“180L Pre-Production Final Overall Quality Inspection” Translation Provided by CNN

180L pre-production final overall quality inspection

Detail from Electrical Engineering (Part 1)

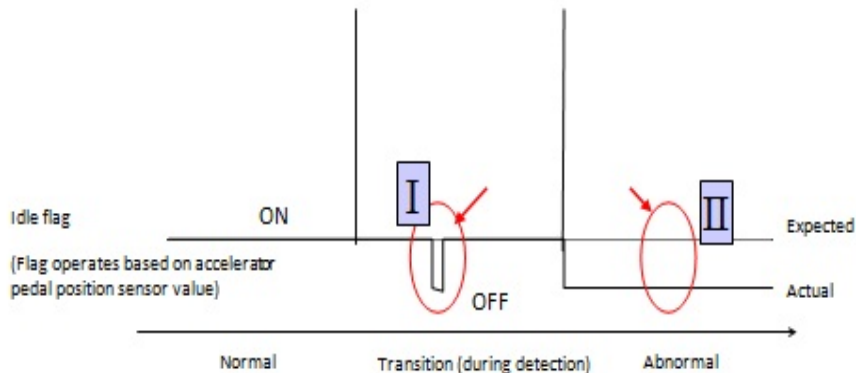
Inaccurate Translation:
"at the start" is the correct statement, instead of "full throttle."
The condition is when the vehicle starts to "creep" (seen in automatic transmission vehicles) during the process the accelerator pedal sensor detects an abnormality (again, the abnormality was intentionally made).

This condition occurred when a stress test was conducted during the development. This translation reads as though the condition occurred in the market, which is NOT the case.

Inaccurate Translation:
"transmission" or "sending" is correct

"Accelerator pedal is pressed" is correct: inaccurate translation and mistaken location of translation

Inaccurate Translation:
"accelerator pedal is fully released" is correct
